14 CFR Part 39

[Docket No. FAA-2013-0023; Directorate Identifier 96-CE-072-AD]

Airworthiness Directives; Various Aircraft Equipped With Wing Lift Struts

ACTION: Notice of proposed rulemaking (NPRM).

Figure 1

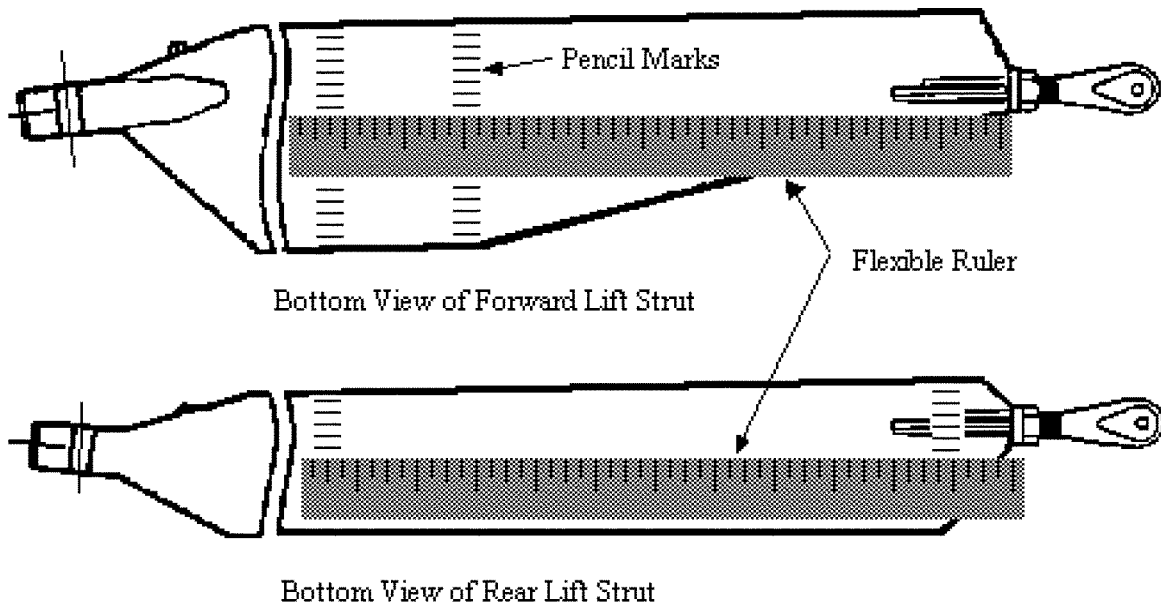
2. Using a flexible ruler, draw a 1/4-inch grid on the surface of the first 11 inches from the lower end of the strut as shown in Piper Service Bulletin No. 528D or 910A, as applicable. This can be done using a soft (#2) pencil and should be done on both faces of the strut. As an alternative to drawing a complete grid, make two rows of marks spaced every 1/4-inch across the width of the strut. One row of marks should be about 11 inches from the lower end of the strut, and the second row should be several inches away where the strut starts to narrow. Lay the flexible ruler between respective tick marks of the two rows and use tape or a rubber band to keep the ruler in place. See Figure 1.
